**CITY OF NAPLES
PURCHASING DIVISION
CITY HALL, 735 8TH STREET SOUTH
NAPLES, FLORIDA 34102
PH: 239-213-7100 FX: 239-213-7105**

ADDENDUM NUMBER 2

NOTIFICATION DATE:	SOLICITATION TITLE:	SOLICITATION NUMBER:	BID OPENING DATE & TIME:
12/20/2021	Directional Drill Services - Naples Beach Restoration - RFP	22-002	1/4/2022 2:00PM

Title PIPELINE PROFILE VIEW	
Project No. 16-329	Scale AS NOTED
Drawing No.	Sheet 9 of 13
	Revision 0

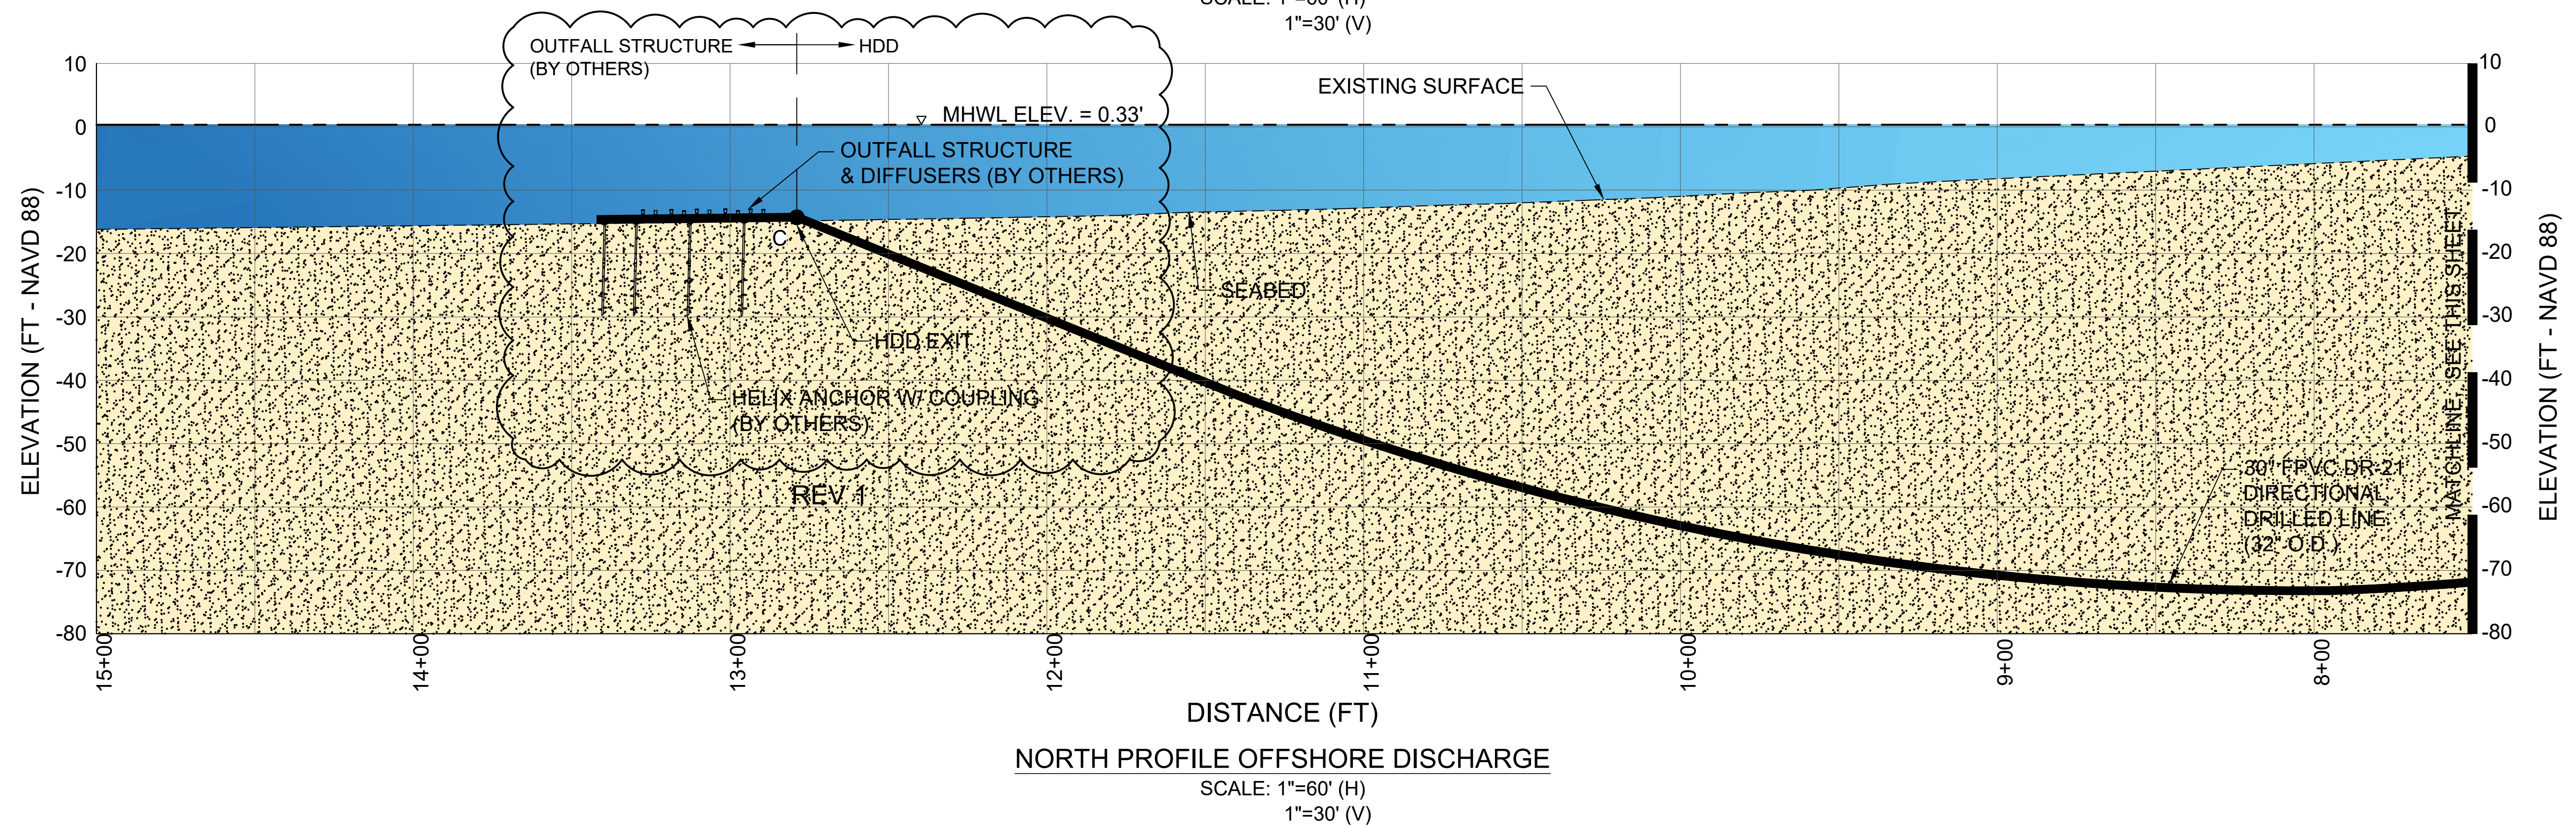
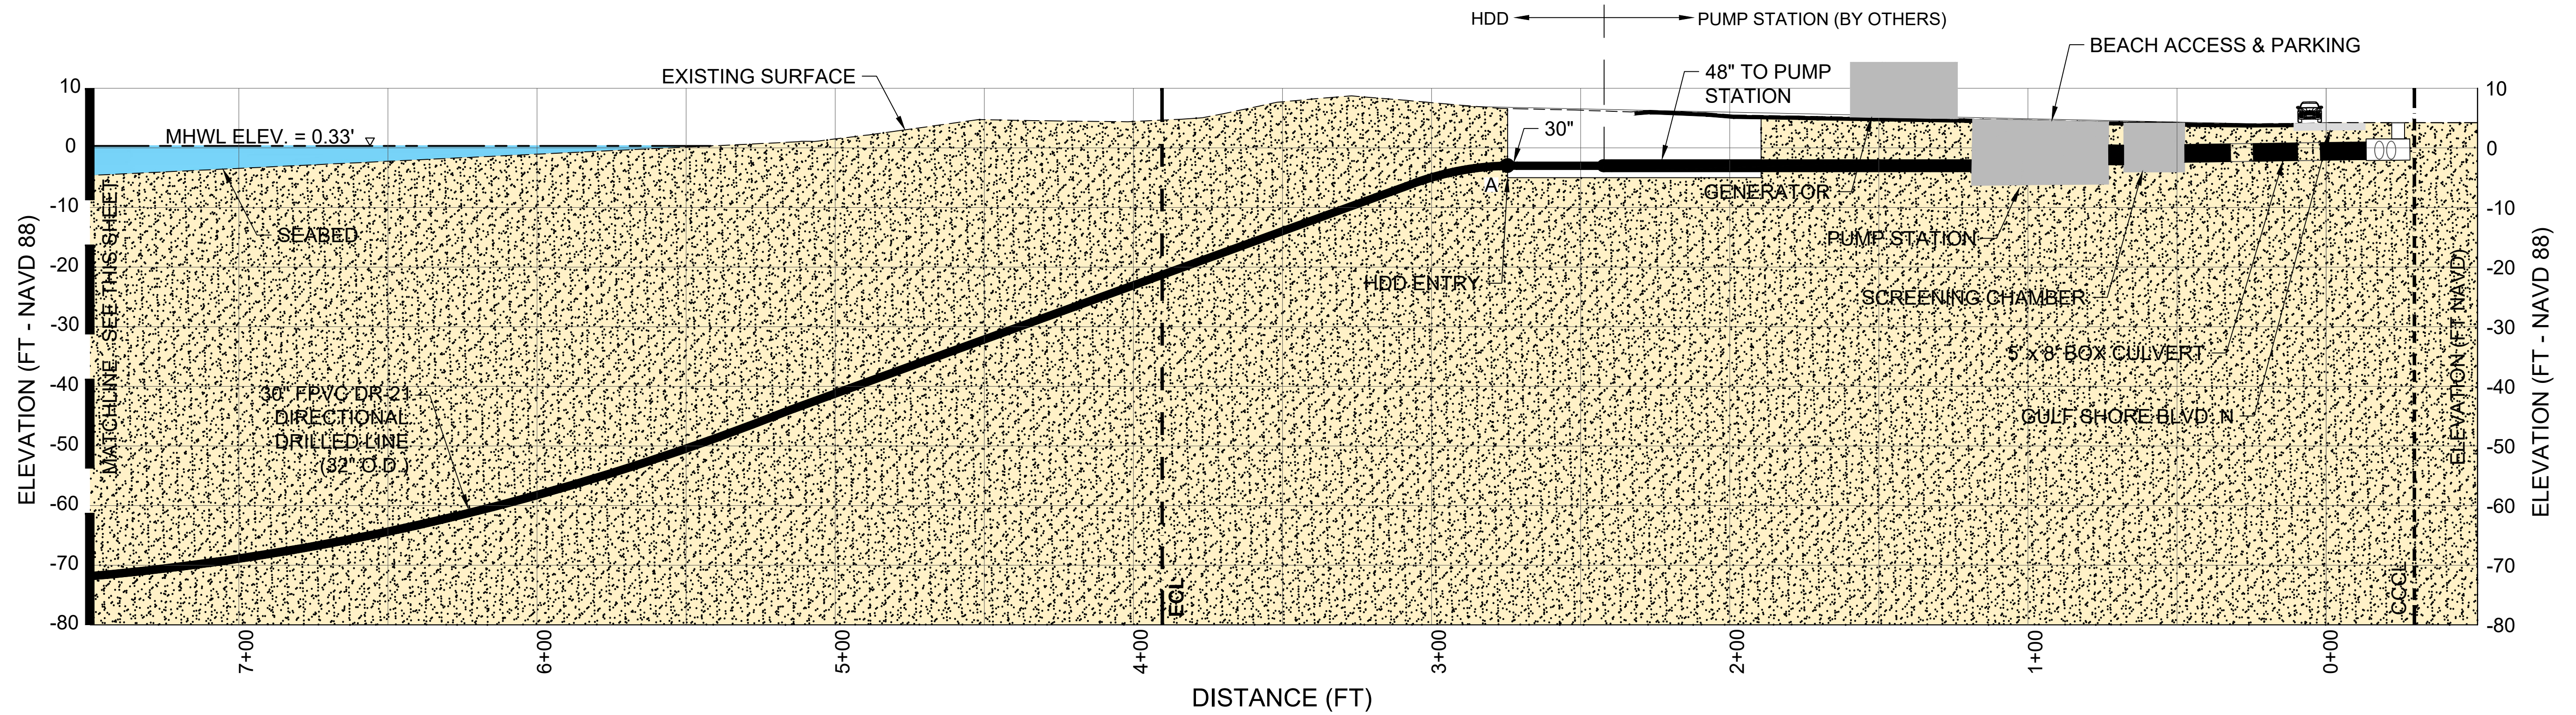
1. While comparing the plan and profile views of the HDD design there appears to be differences of the location of the end of the HDD and outfall structure. More specifically, on the profile view of the north and south HDDs (page 9 & 10 of 13) the north installation point "C" is shown at station ~14+13 and the south installation point "D" is at station ~13+14. When looking at the plan view drawing (page 8 of 13) point "C" appears to be as station ~12+31 and point "D" at ~12+81. Please advise on the intent and if possible provide updated drawings reflecting the correct location.

ANSWER: Comment is noted. Refer to the revised profile views Sheets 9 and 10, exhibit B.
